Diversified Communications  
Proposed Tenant Improvements  
121 Free Street,  
Portland Maine, 04101

1st Floor Plan, north

A1.01

Revision, 12-16-2013:

I First Floor Plan (north)  
3/16" = 1'-0"

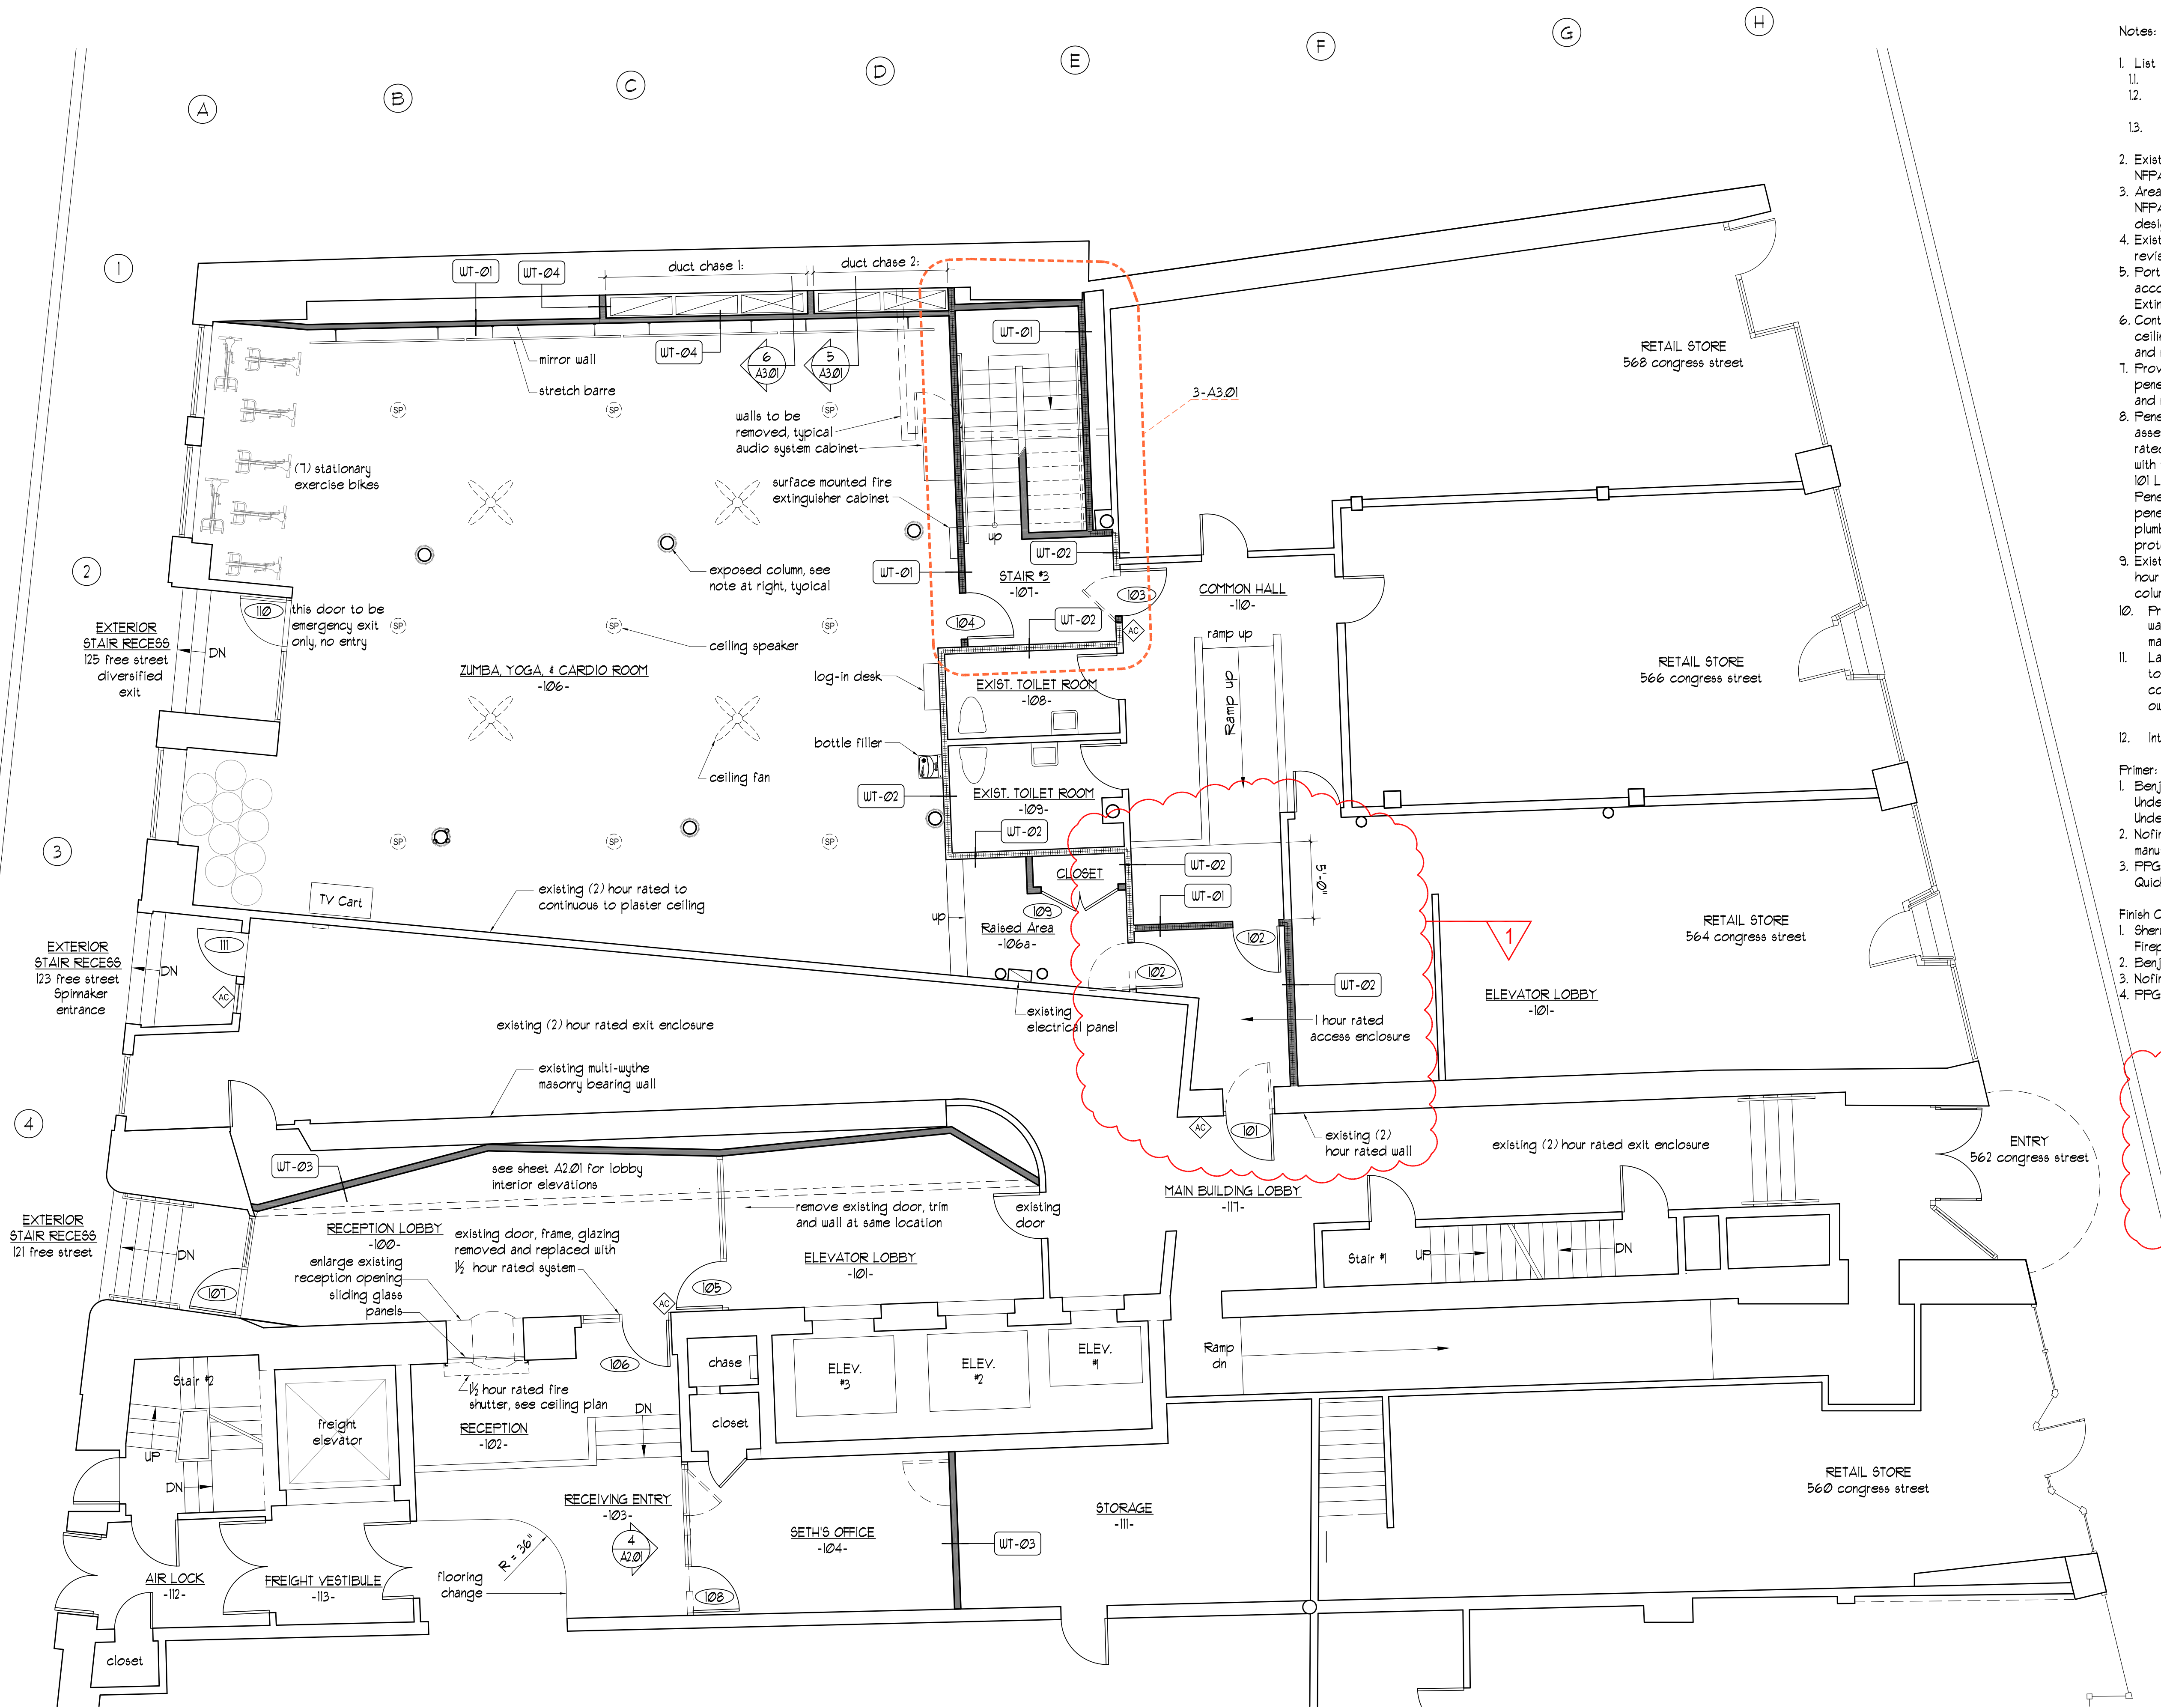
1. Added 1 hour rated fire access enclosure per NFPA 101 section 7.1.3.1. Walls to be 1 hour rated. Additional door 112 and frame to be 1 hour rated
